Post-Tender Addendum No. 1

Project No: 25271

Project: **Clarington Gardens Phase 2 - 4 Storey Multi-Residential Building**
GAY COMPANY LIMITED

1.1 DRAWING S201 – FOUNDATION PLAN & SECOND FLOOR FRAMING PLAN

2 / S201 SECOND FLOOR FRAMING PLAN
1:100

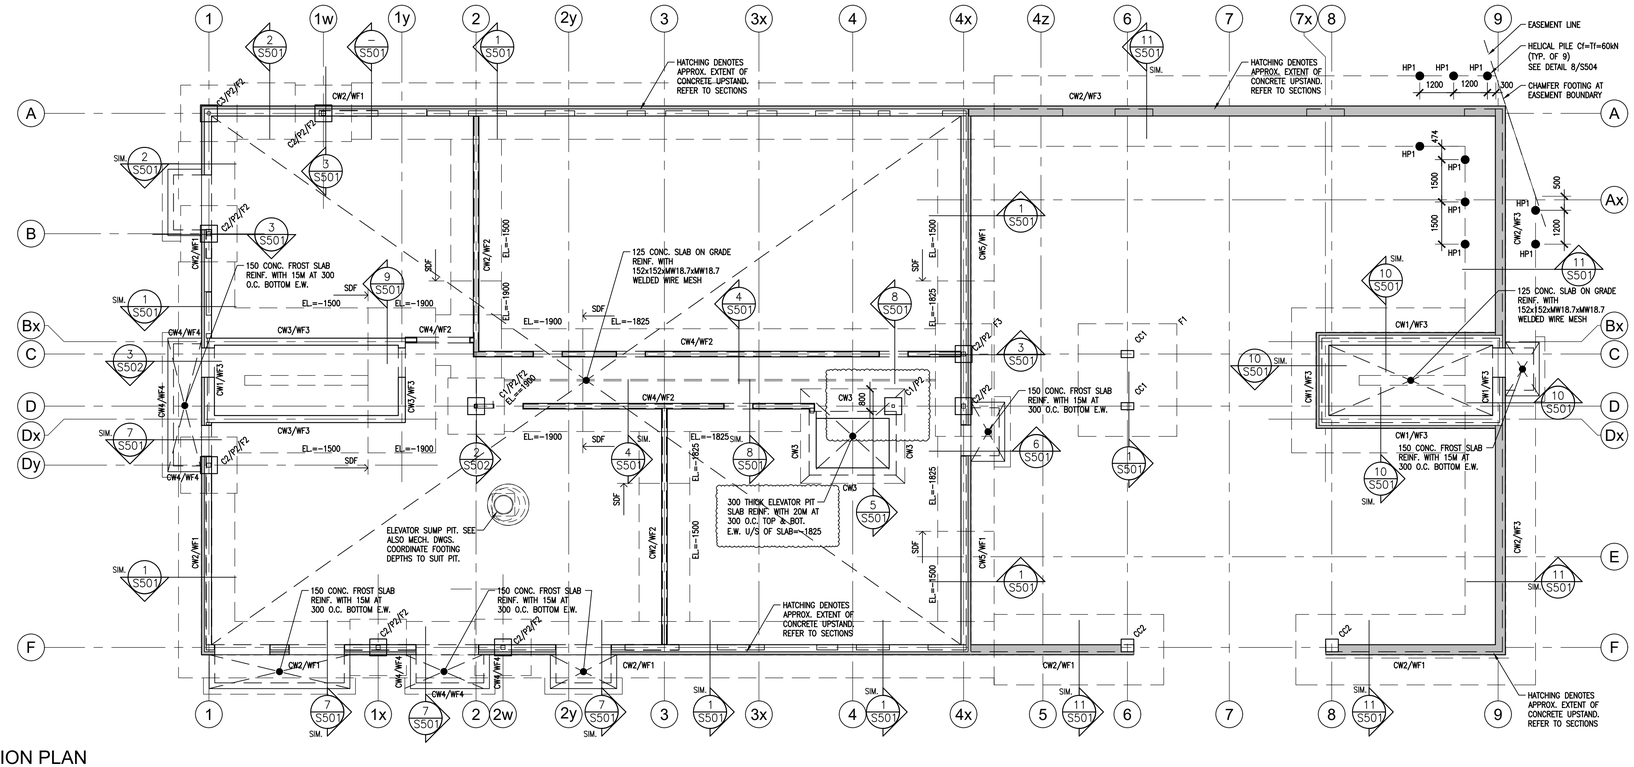
.1 Column and pier added on 1/S201 along Gridline D, between Gridline 4 and 4x.
.2 Elevator base pad extended past Gridline D to accommodate new pier added.
.3 Column and beam added on S/S201 along Gridline D, between Gridline 4 and 4x.
